**RESOLUTION HOLDING HEARING ON REQUEST FROM  
PINNACLE ON FLEUR, LLC FOR APPROVAL OF PUD FINAL DEVELOPMENT PLAN  
FOR “PINNACLE ON FLEUR” FOR PROPERTY AT 2710 FLEUR DRIVE**

Communication from the City Plan and Zoning Commission advising that at their June 4, 2020 meeting, the following action was taken regarding a request from Pinnacle on Fleur, LLC represented by William Kimberly (officer) for review and approval of a PUD Final Development Plan "Pinnacle on Fleur" on property located at 2710 Fleur Drive, to allow development of 20 household units within three (3) Row Type Buildings in accordance with the approved PUD Conceptual Plan requirements.

## STAFF REPORT TO THE PLANNING COMMISSION

**CC**  
**2241**  
**SHEET**  
**5 OF 5**

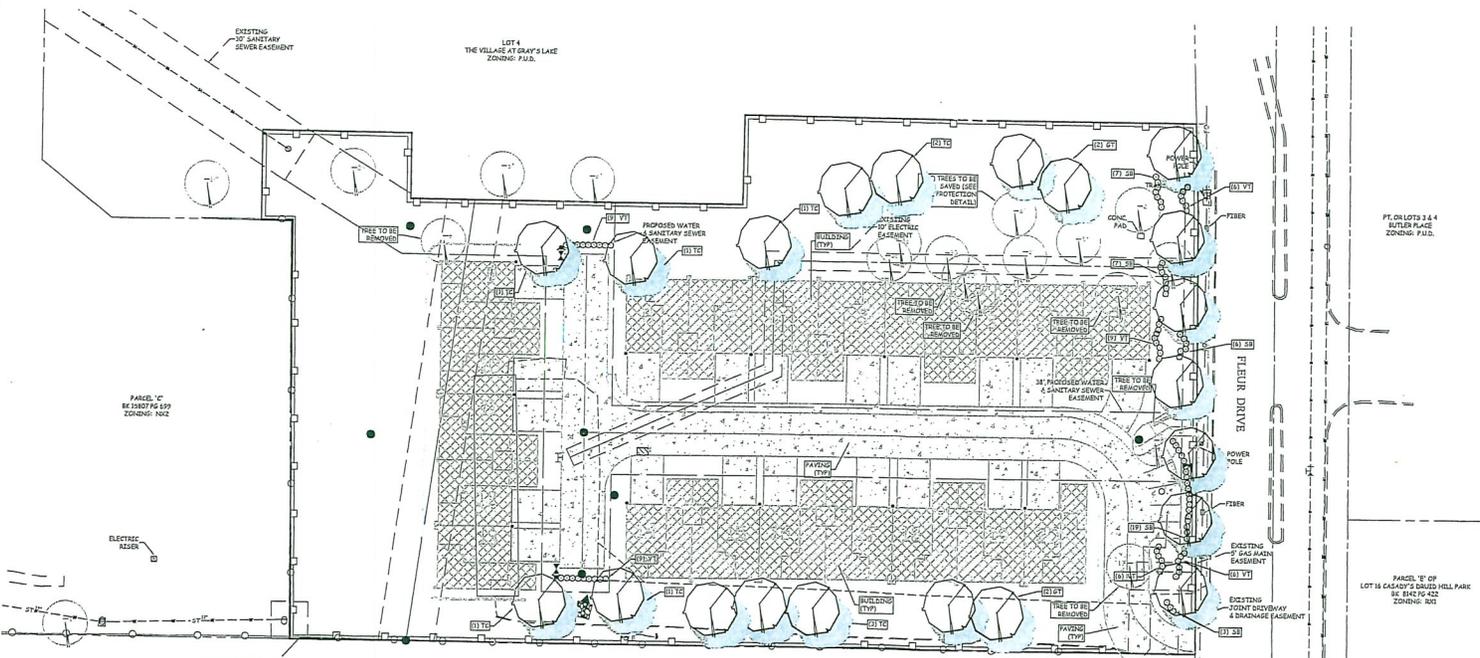
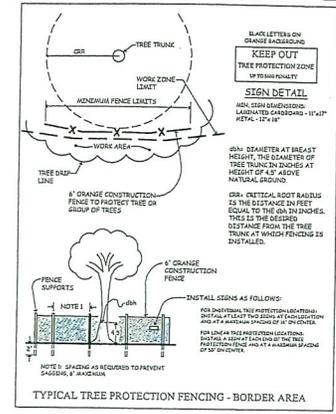
- A) Streetscape: Add street trees within the right-of-way spaced 30' apart. Trees should be no closer than 15' to a street light. This should be coordinated with City Engineering Design staff with the Fleur Drive streetscape project.

- A) Streetscape: Add street trees within the right-of-way spaced 30' apart. Trees should be no closer than 15' to a street light. This should be coordinated with City Engineering Design staff with the Fleur Drive streetscape project.

Project No.	20020120
Date	05/18/20
Drawn By	JW/R/S
Checked By	
Scale	
Sheet Title	CLUSTER 8 ELEVATIONS
Sheet No.	20

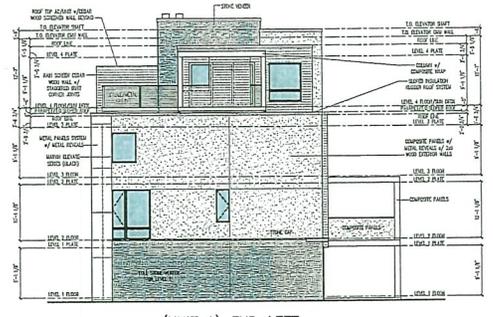
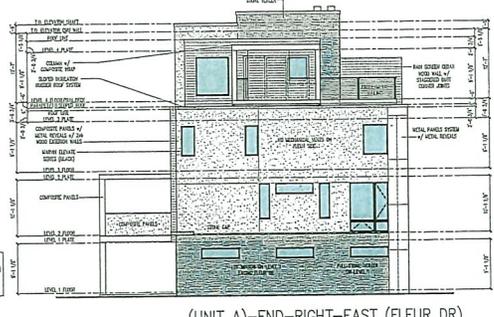
The PUD Conceptual Plan Amendment required that the end facade of the units closest for Fleur Drive is required have a separate prominent pedestrian entrance either from the garage or unit that would have a walkway to the private drive. This entrance is required to have an awning reflective of the building design. This is consistent with other Row House Type end facades in other developments when the main entrances of the units have not faced a public street but rather a private drive. The submitted plan does not provide for elements and any approval of the PUD Final Development Plan must be subject to meeting the requirements of the PUD Conceptual Plan as amended.

Provision of the required end unit elevations for facades of the units closest for Fleur Drive with a separate pedestrian entrance either from the garage or unit that would have a walkway to the private drive. The entrance shall be defined with a design appropriate awning or cover to the satisfaction of the Planning Administrator.
